LOWER BASKET 1171745126 REPLACEMENT

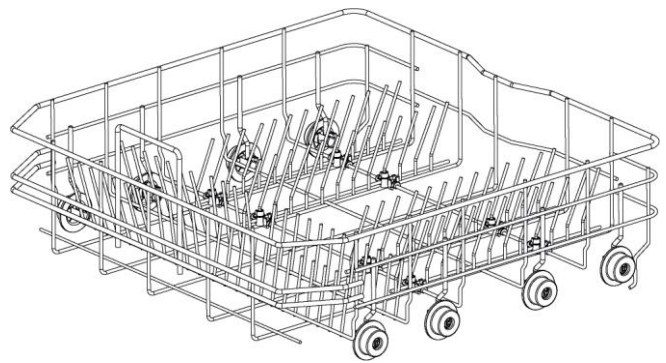
Lower basket 1171745126 will not be available. It can be replaced by lower basket 140002678062. In some dishwashers new layout of basket tines could interfere with cutlery basket. In that cases cutlery basket replacement may be needed.
